Subject: Duke Energy Carolinas, LLC
Oconee Nuclear Station, Units 1, 2, and 3
Docket Numbers 50-269, 50-270, and 50-287,
Renewed Operating Licenses DPR-38, DPR-47, and DPR-55
Licensing Basis for the Protected Service Water System - Responses to
Request for Additional Information - Supplement 4

Responses to Request for Additional Information
Supplement 4

**FIGURE 141-1: Comparison of ONS UFSAR Figure 2-55 and El Centro Time History 5 %
Damped Response Spectra**

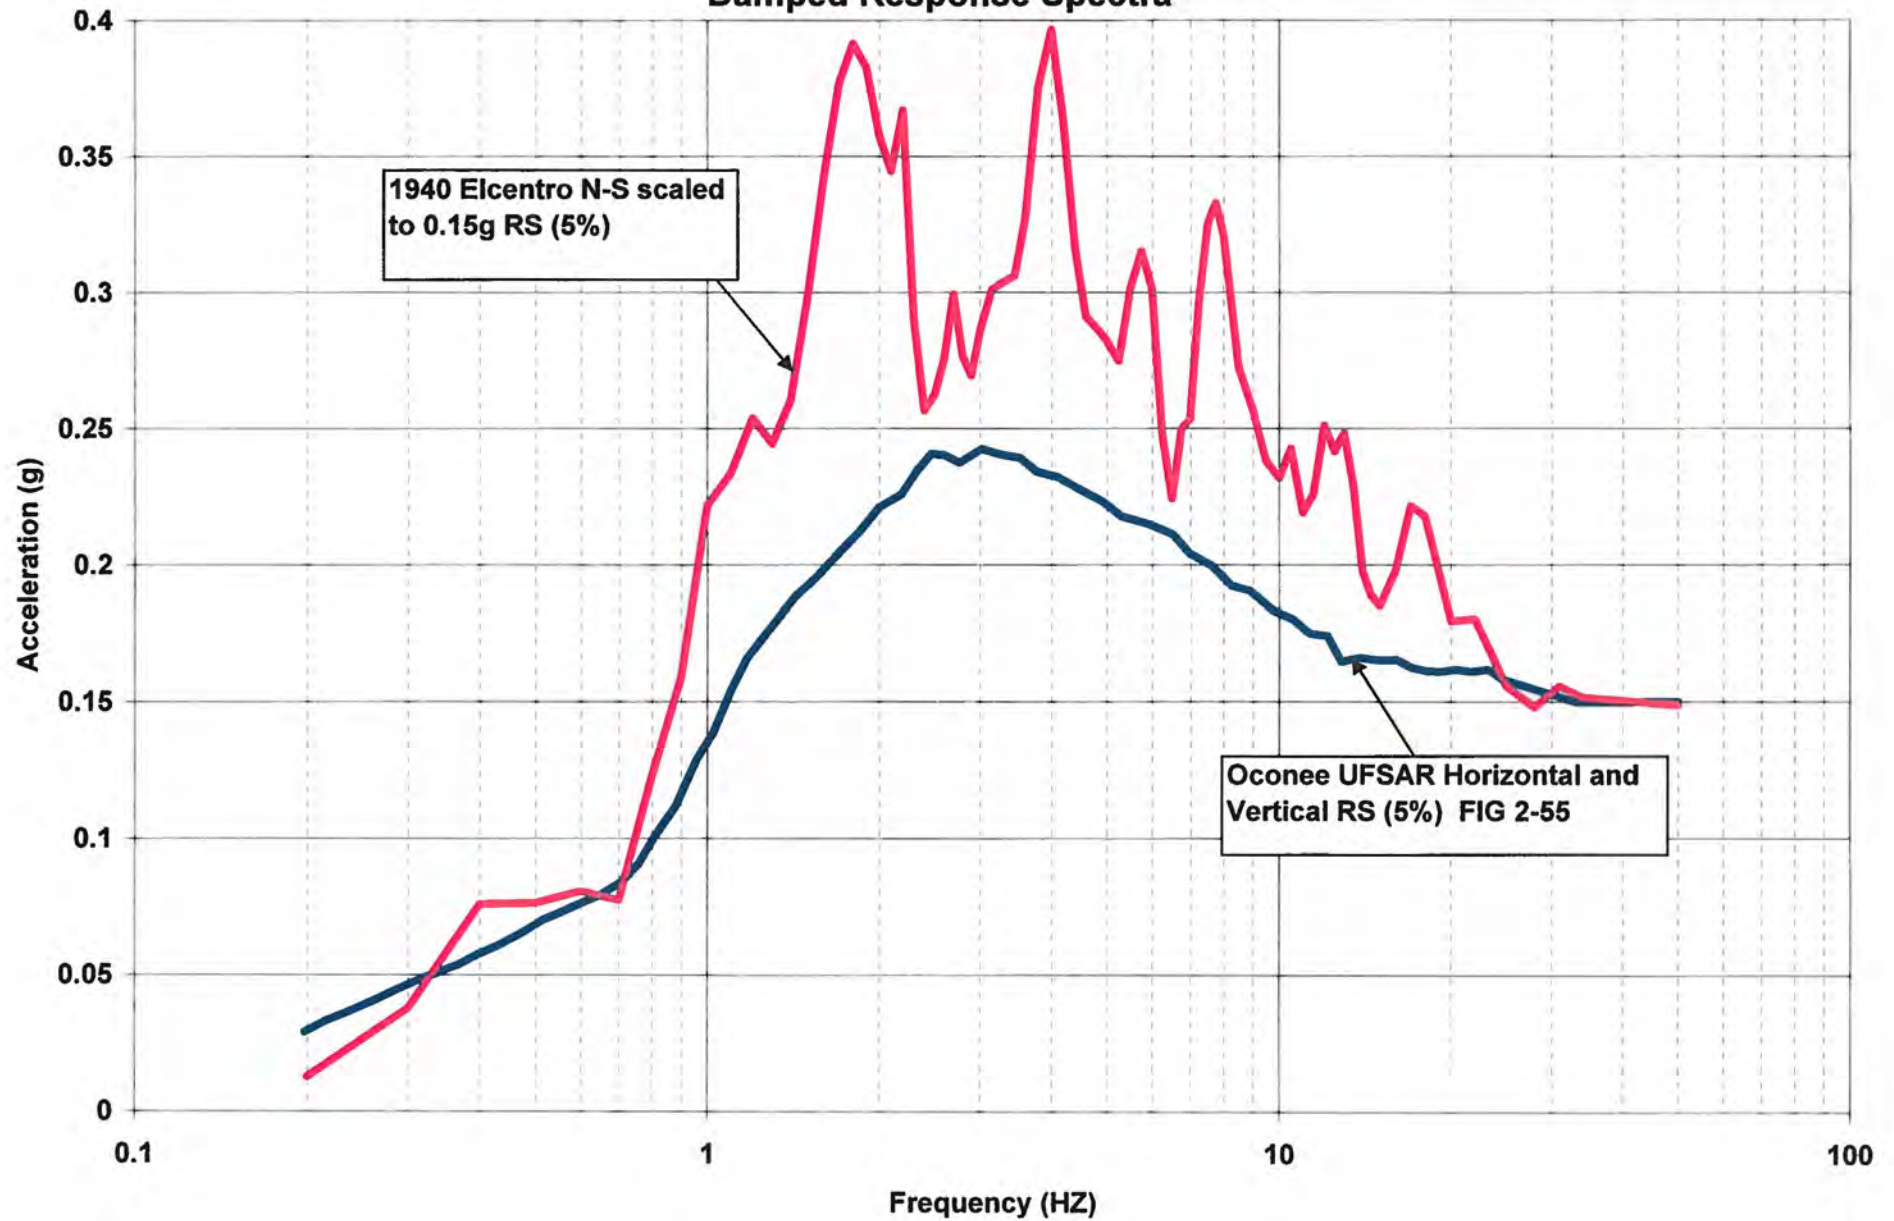
- b) Provide a detailed description of the procedures used for the seismic analysis of the PSW building and to develop the in-structure response spectra (floor design response spectra). If different from the methods and acceptance criteria outlined in the NRC standard review plan (SRP) 3.7.1 and 3.7.2, identify those differences and provide justification that the PSW building is adequately designed, using these alternative methods, to withstand the effects of earthquake loads.

Protected Service Water (PSW) building is founded on subgrade. For the PSW building design, the Maximum Hypothetical Earthquake (MHE) response spectra presented in Updated Final Safety Analysis Report (UFSAR) Figure 2-55, "Recommended Response Spectra" was used, consistent with Oconee Nuclear Station (ONS) licensing basis (UFSAR Section 3.7.1.1 "Design Response Spectra"). For the PSW building MHE In-structure response spectra (ISRS) generation, the time history record of the North-South (N-S), May 1940 El Centro earthquake normalized to a peak acceleration of 0.15g was used as the input ground motion for both the vertical and horizontal excitation consistent with the ONS licensing basis (UFSAR Section 3.7.1.2 "Design Time History"). The 5% damped response spectra of the North-South (N-S), May 1940 El Centro earthquake normalized to a peak acceleration of 0.15g essentially envelopes the design response spectra of UFSAR Figures 2-55 as shown in Figure 141-1 considering that the lowest fundamental frequency of the PSW building models is 6.23 Hz. (Tables 141-7 to 141-10).

The PSW building design has been reevaluated for this revised response to NRC RAI 141 [EMCB6]. For this reevaluation, reanalysis of the PSW building has been performed using the "as built" configuration. For the reanalysis, the response spectra method of analysis was used to determine maximum design forces of various structural components of the PSW building and maximum foundation soil bearing pressures. The response spectra specified in ONS UFSAR Figure 2-55 for structures on subgrade was used as the MHE
